OPB LU 21-012886 DZM GW opb's apparent lowballing of construction value has hampered these reviews

2017 Design Review
 submittal plan
 3/17/21

SITE SUMMARY - NONCONFORMING DEVELOPMENT PLAN LU-17-203778

LU 17-203778 D2

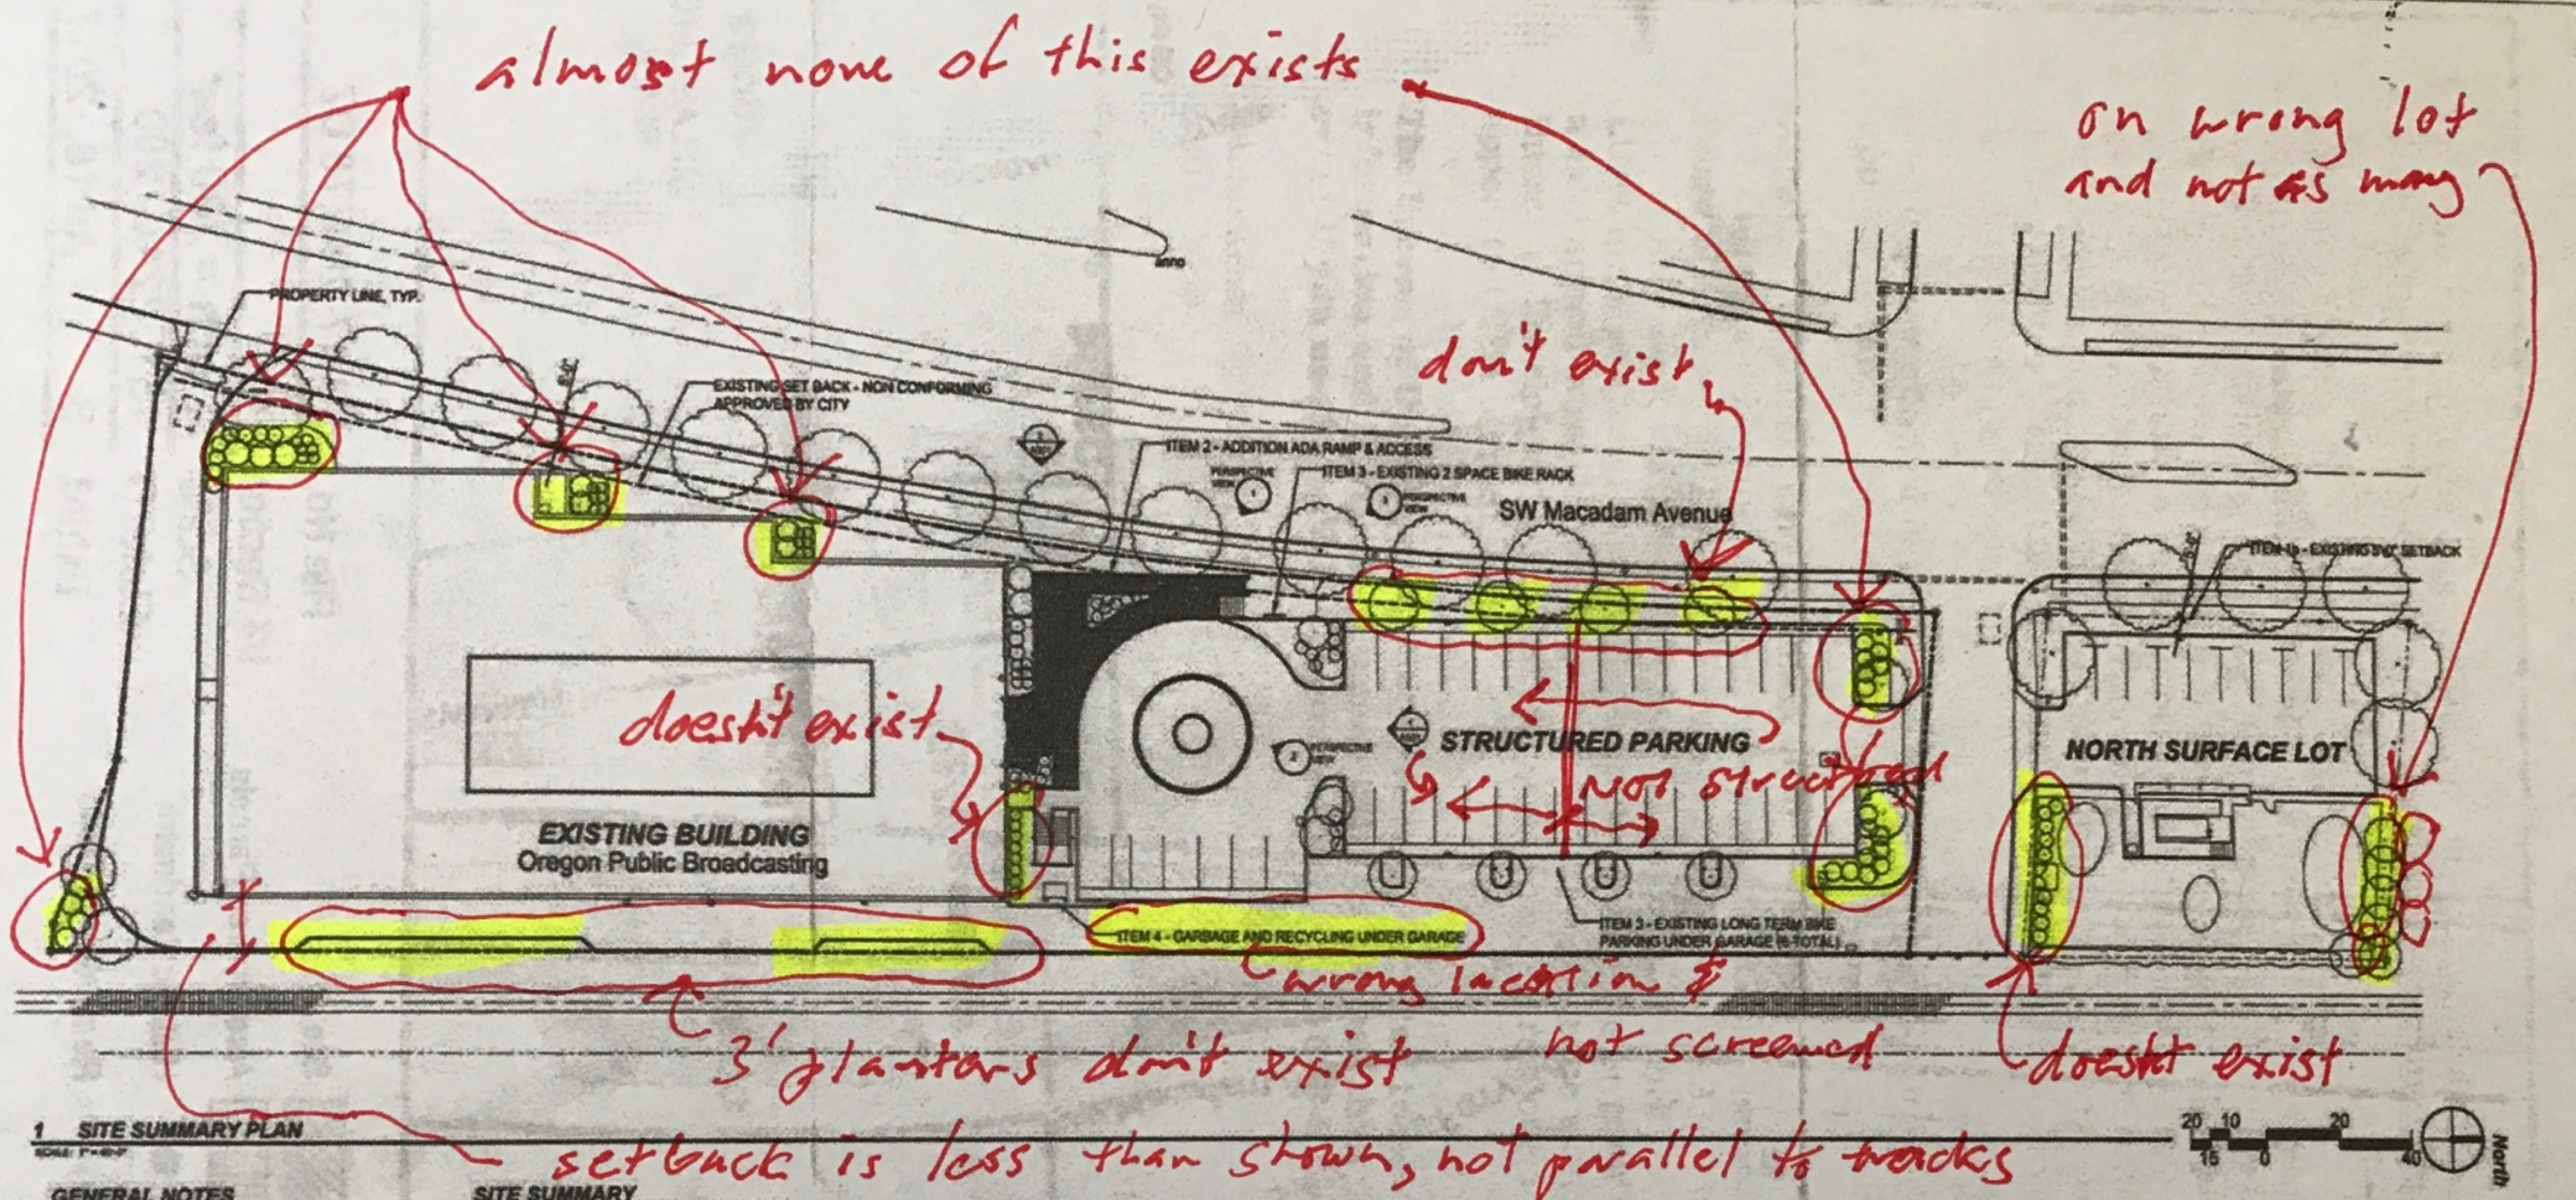
I've given Hannah Bryant many examples of OPB submitting incorrect information in this review, and in the earlier land use review for the renovation that triggered it. One graphic example is the attached site plan for the earlier review, on which marked things that were not correct.
